Response to Comments and Minor Revisions

Initial Study/ Negative Declaration

El Dorado Irrigation District Temporary Reservoir Re-operation Water Transfer

June 2026

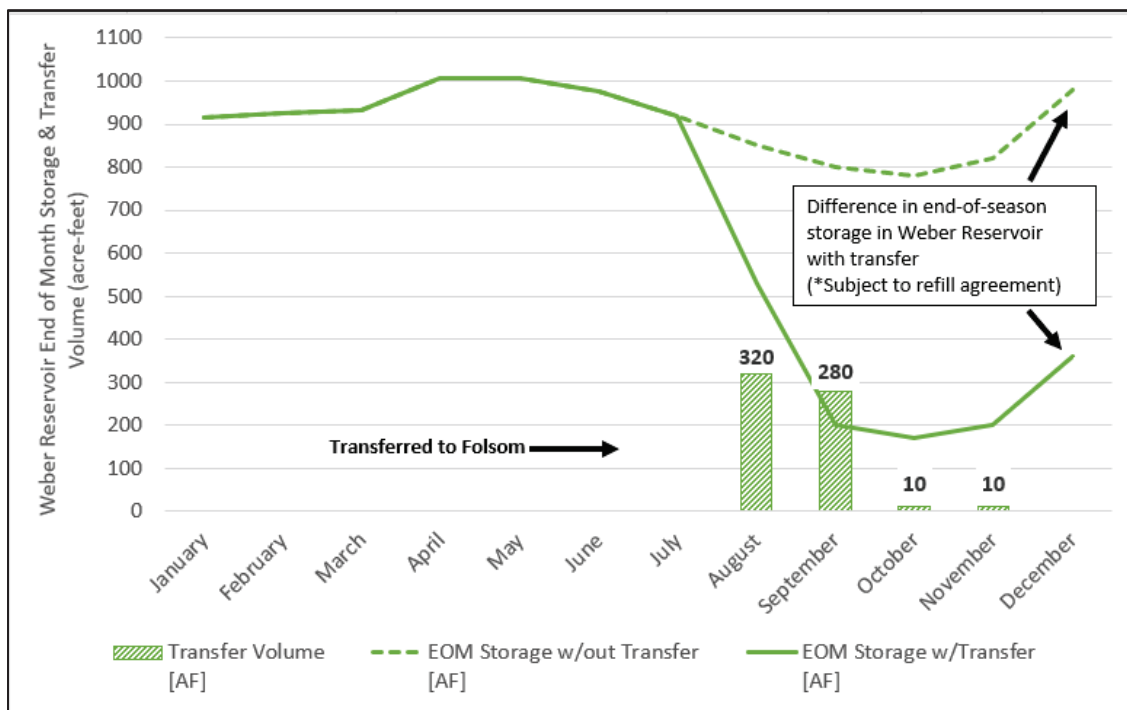
1. Figure 2-4 contained in the May 13, 2026 IS/ND (page 2-12) contains a discrepancy in the legend, which mislabeled the end-of-month storage with transfer and without transfer curves. Figure 2-4 is replaced with the following figure that corrects this minor labeling error. The revision to the legend does not affect the impact analysis or significance determinations in the IS/ND. These corrections are an insignificant modification to the IS/ND and do not change the adequacy of the analysis.
